ALERT SERVICE BULLETIN

SUBJECT: REVISION "A" TO ALERT SERVICE BULLETIN 206-02-99: (MAIN ROTOR BLADES 206-010-200-ALL INSPECTION AND REWORK OF)

SUBJECT: MAIN ROTOR BLADES 206-010-200-ALL
INSPECTION AND REWORK OF

Figure 1. Area to inspect

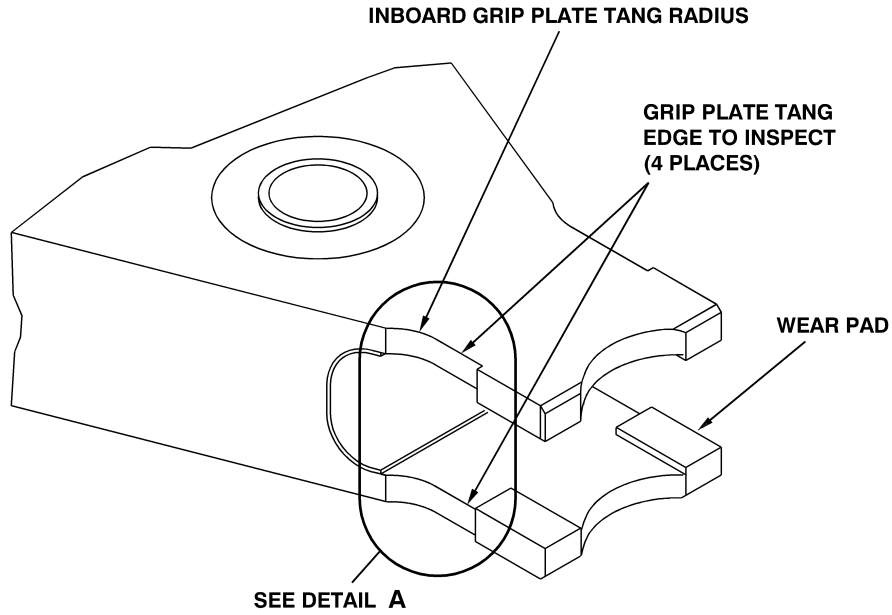
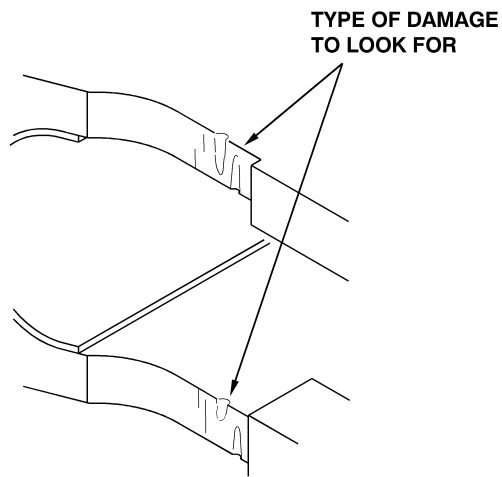
- A**
1. Inspect the blade grip plate tangs leading and trailing edges between the wear pads and the inboard radius for presence of tool marks (Figure 1). The surface should be flat, with no waves or notches (Figure 1, DETAIL A).
 2. If a damage or an irregularity on the surface as shown on the Figure 1 is found, do PART II of this Alert Service Bulletin.
 3. If no damage or irregularity on the surface as shown on the Figure 1 is found, the blade is serviceable.
 4. Using a vibrating stylus, mark ASB 206-02-99 on the blade Modification Plate to indicate that this Alert Service Bulletin has been accomplished.
 5. Make an entry in the Helicopter and the Component Historical Records to show that this Alert Service Bulletin is completed.

3. Measure the depth of the damage.
4. If the depth of the damage exceed 0.050 inch (1.27 mm) remove the blade from service.
5. Send the defective blade to Bell Helicopter Customer Property Return with a Malfunction Report attached with the ASB number in reference.
6. If the depth of the damage is at 0.050 inch (1.27 mm) or less do PART III of this Alert Service Bulletin.

1. Using a single cut general purpose half round file No 2 or 3 (smooth cut) blend smooth the damages in a ratio of 10 to 1. As an example, if the damage is 0.040 inch (1.5424 mm) deep, blend 0.400 inch (15.24 mm) on each side of the damage. The maximum depth after rework is 0.050 inch (1.27 mm).
2. After blending with the file, polish the surface with 180-220 grit Aluminum Oxide Fabric Cloth to obtain a finish of 63 RMS.
